VALUE ENGINEERING STUDY

Project # STP00-0198-01(020) PI No. 132610-

SR60 Widening & Reconstruction in Murrayville
Hall County, Georgia

23 June 2011

R-22.0 Current Design Jerry Burress Road Intersection

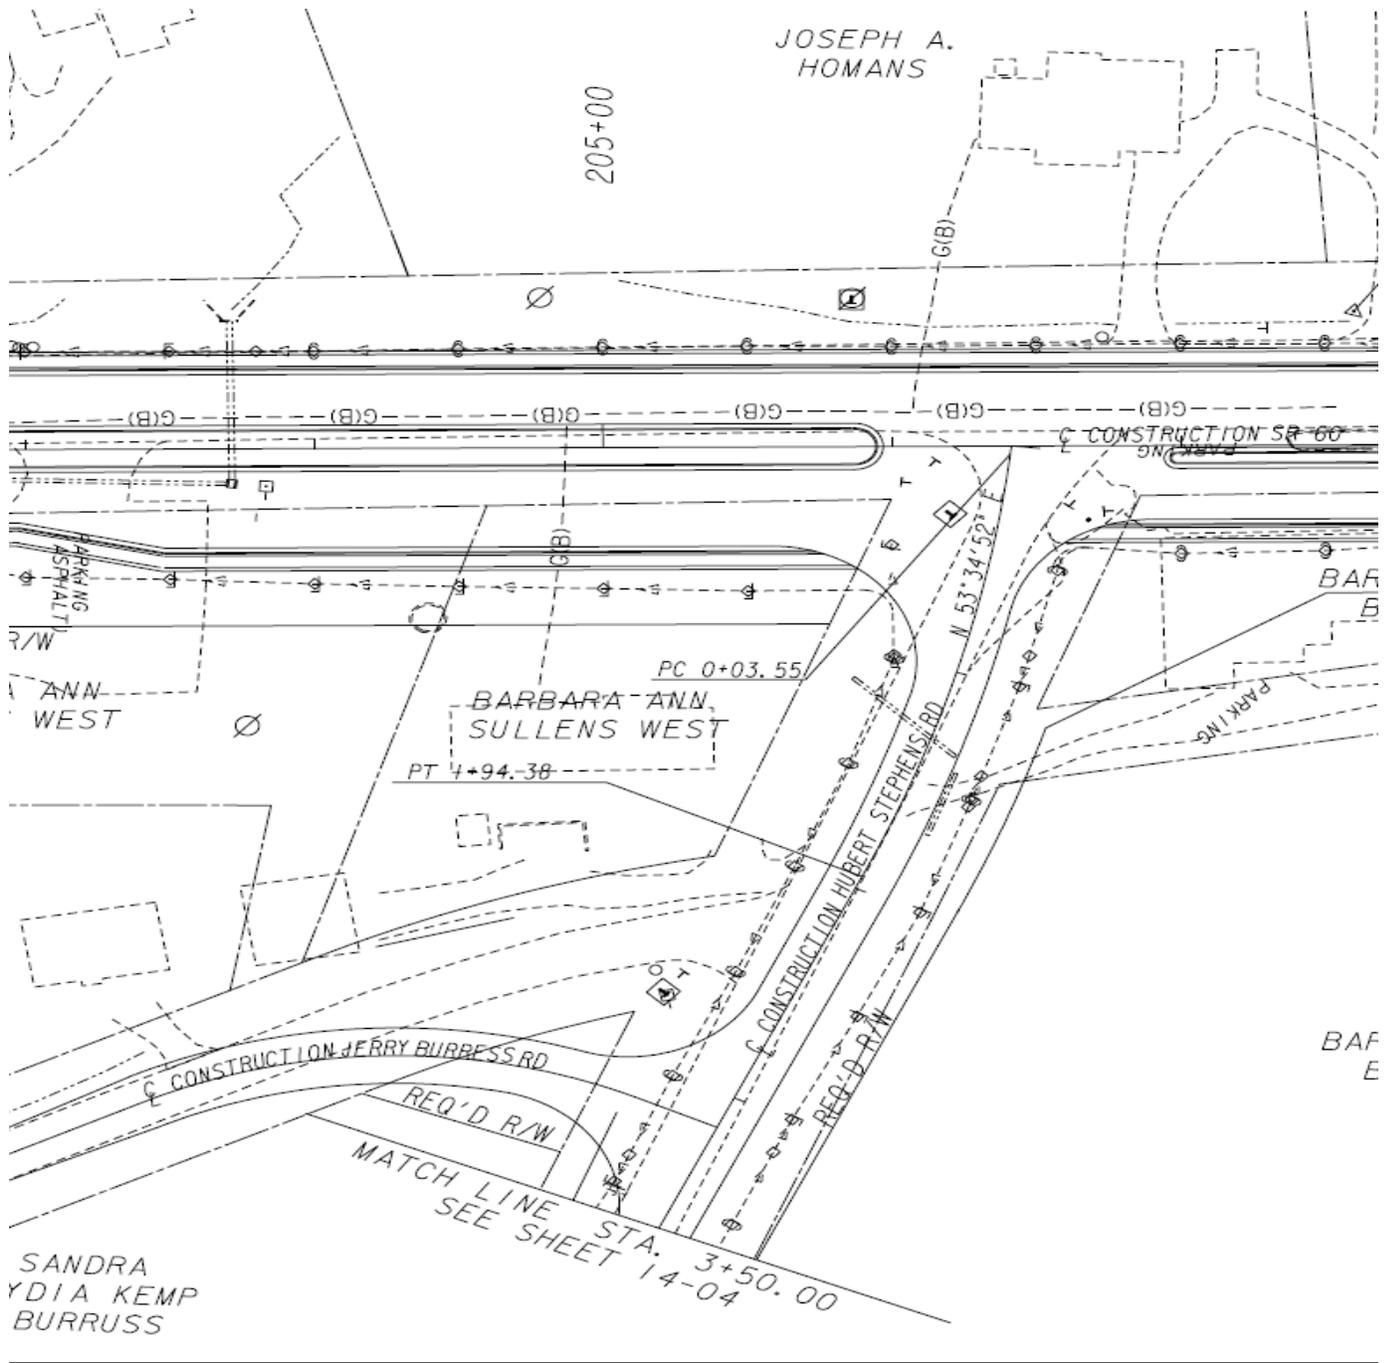
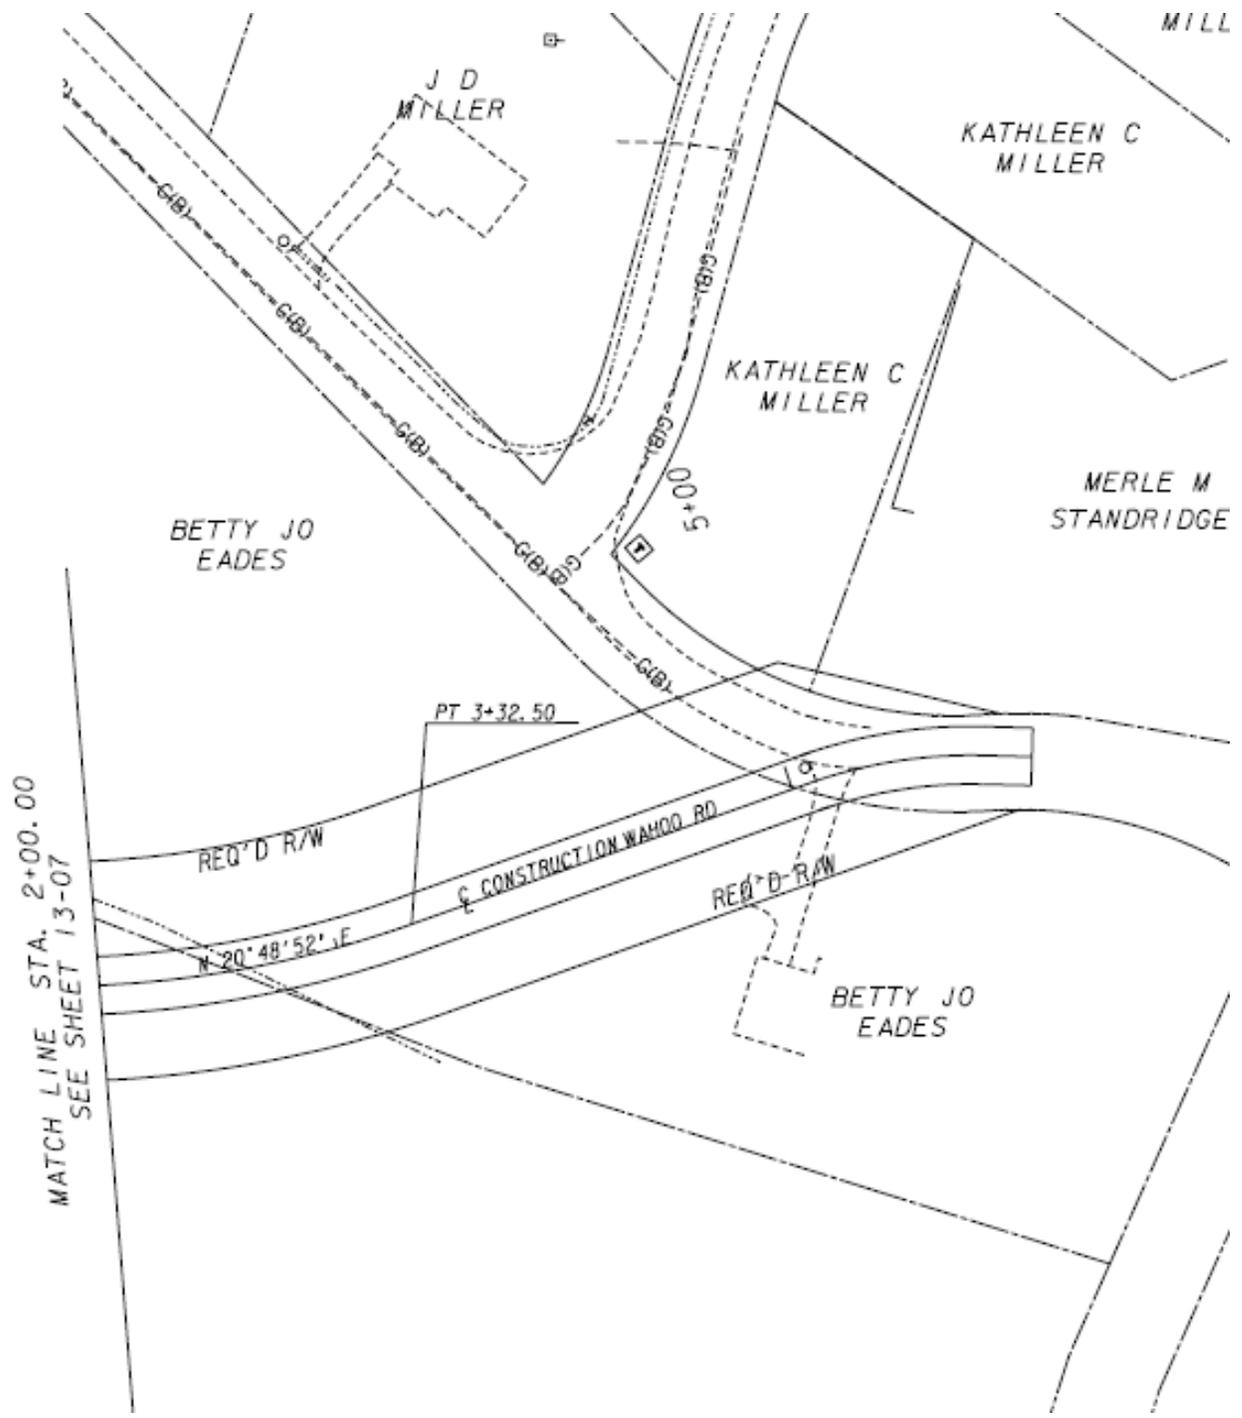
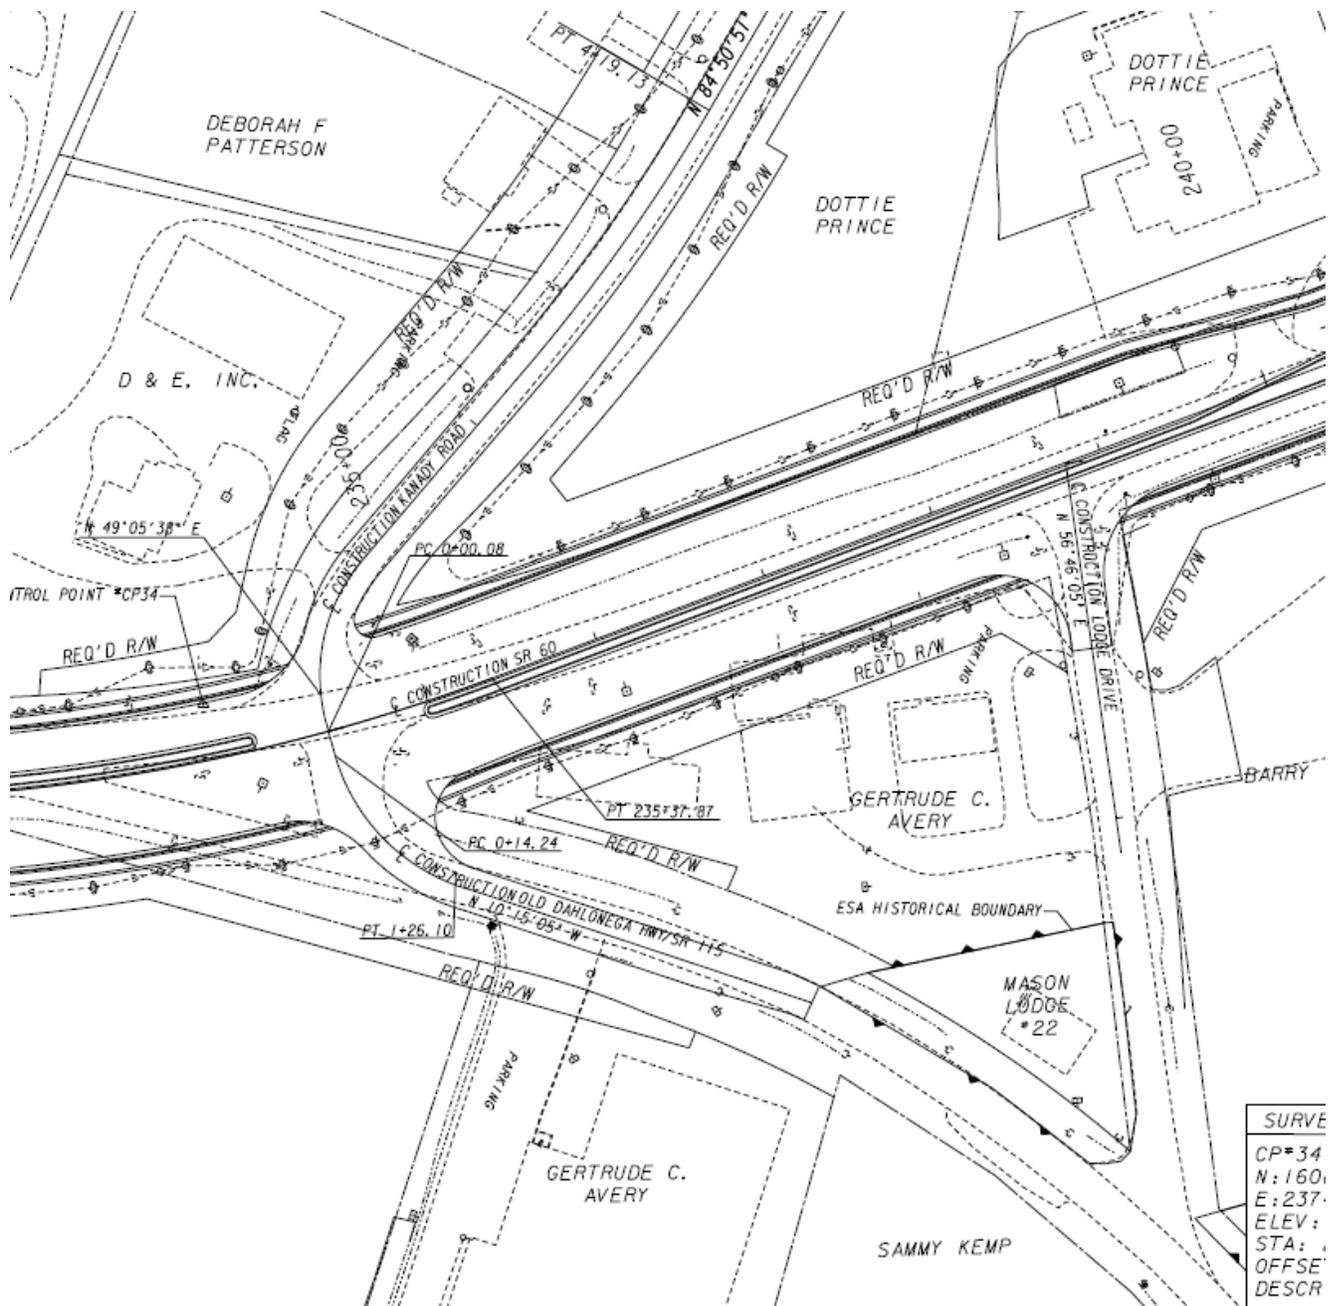
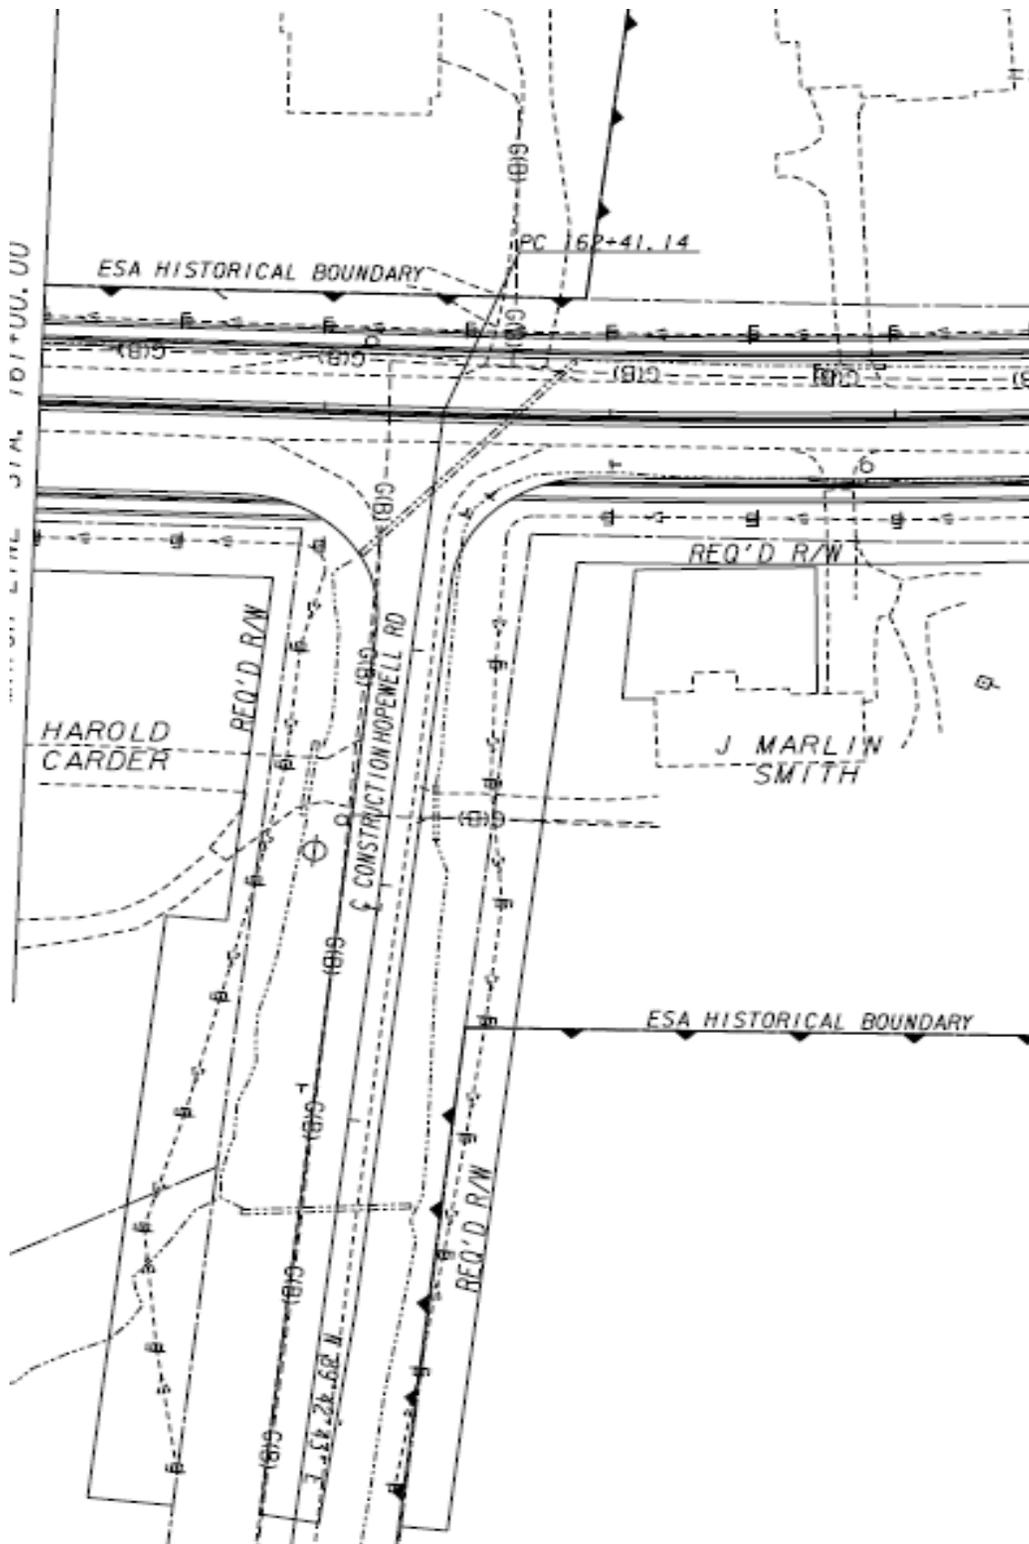
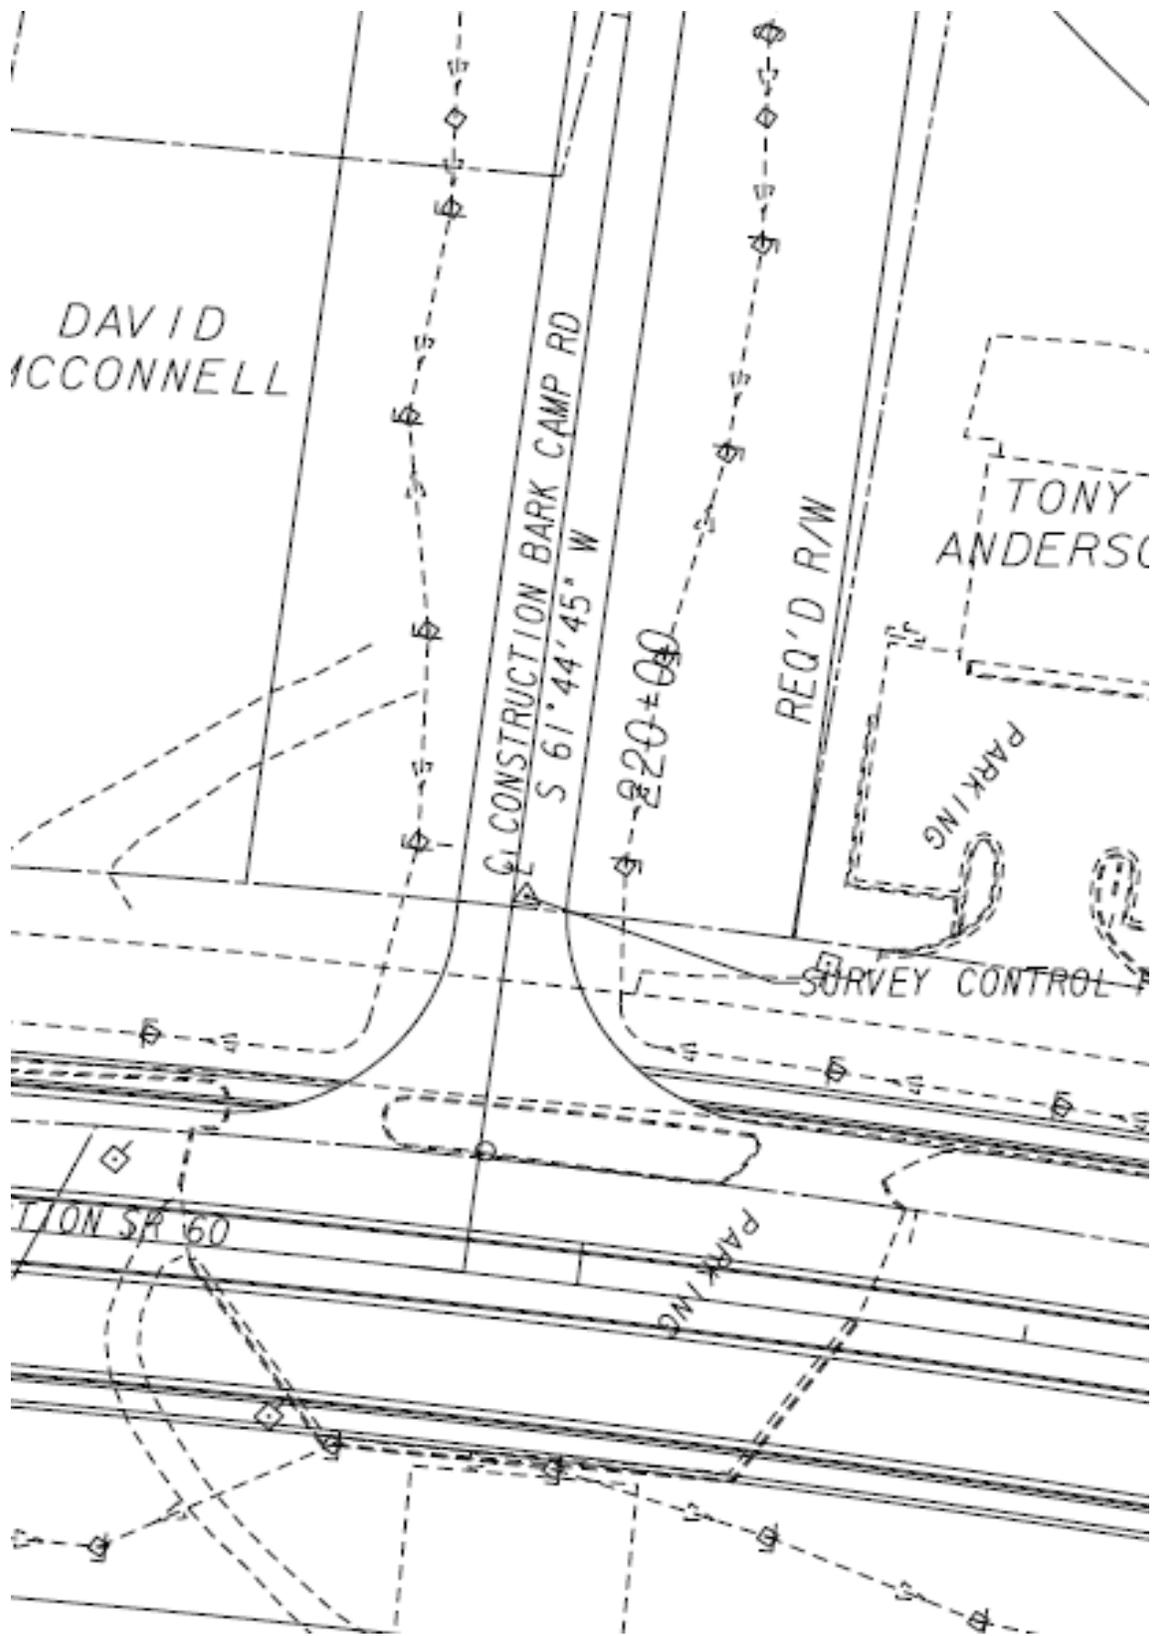
PROPOSED CHANGE: The proposed recommendation is to eliminate realignment of existing side roads Jerry Burress Rd., Wahoo Rd., Old Dahlonega Hwy, Kanady Rd., Hopewell Rd, Bark Camp Rd., Elrod Rd., Yellow Creek Rd.
